PlanGrid Task Report - Jun 21, 2024

18 tasks in this report.

Sheet
M1.1

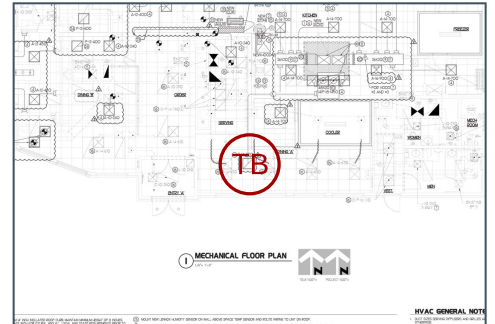
Description
Return Grille 2-1 could not be located in the space. Per M1.1 it should be located adjacent to diffusers 1-1 and 1-2 (side dining area).
*Reference NTi GRD Layout.

No change

M1.1

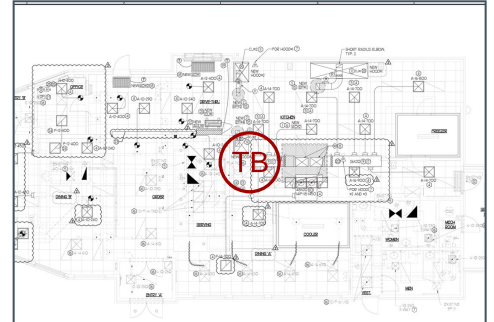
Hood 3 is currently labeled Hood 2. Recommend a corrected label be installed

No change

Sheet
M4.2

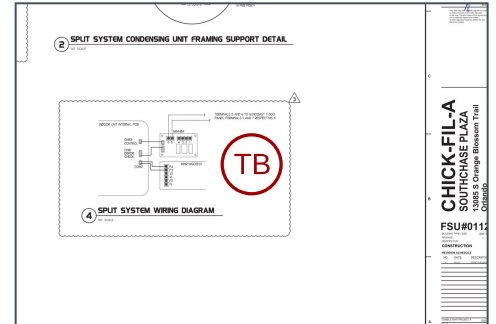
Description
Mini split control wires not landed in suncoast panel.

No wires landed 6/19

IMG_2809
Stephen Tassinaro
Apr 24, 2024 10:56 AM

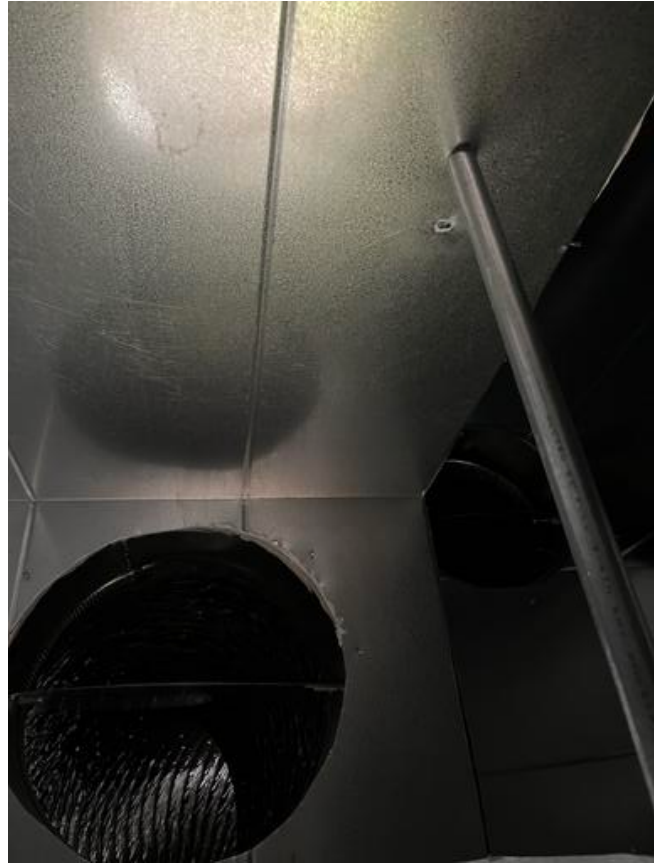
Dampers to be installed parallel to airflow. In horizontal runs, position damper on left or right at 9 or 3 o'clock. On vertical ducts position damper on bottom only (6 o'clock). RTU 2 return dampers incorrect orientation.

No change to return damper orientation on RTU 2

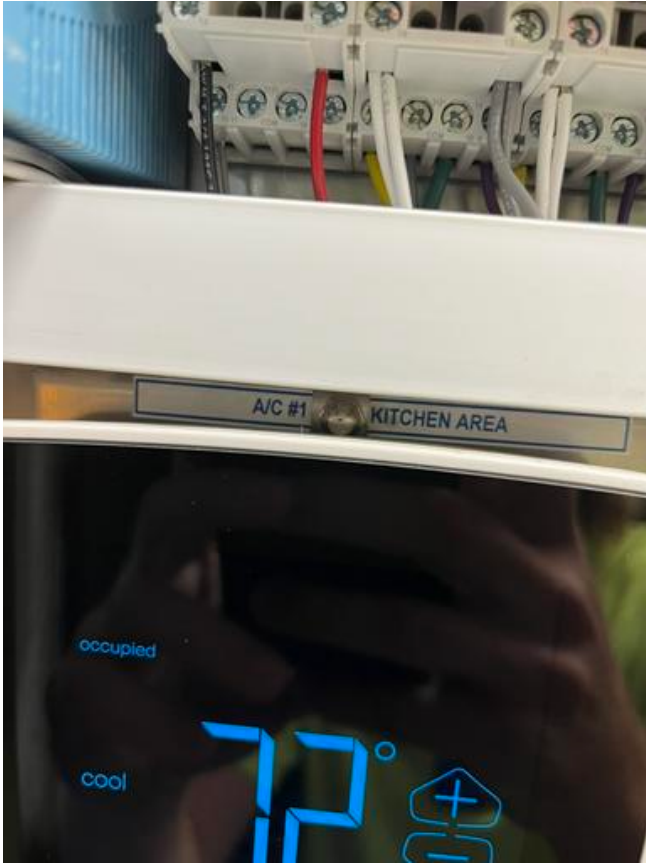
Label all sensors, humidistats, thermostats, smoke annunciators and remote space mounted OADs, MODs, VFD's for which piece of equipment they serve. Remote sensors labeled incorrectly (wrong units). Thermostats 1 and 2 labeled incorrectly (switch labels).

All sensors are now labeled but the label numbering does not match the mechanical plans. Per the mechanical plans: RTU 1 - Side Dining, RTU 2 - Kitchen, RTU 3 - Dining "B", RTU 4 - Dining "B" (where playroom previously existed).

Thermostat labeling not corrected. RTU 1 serves the side dining and RTU 2 serves the kitchen, per the mechanical plans.
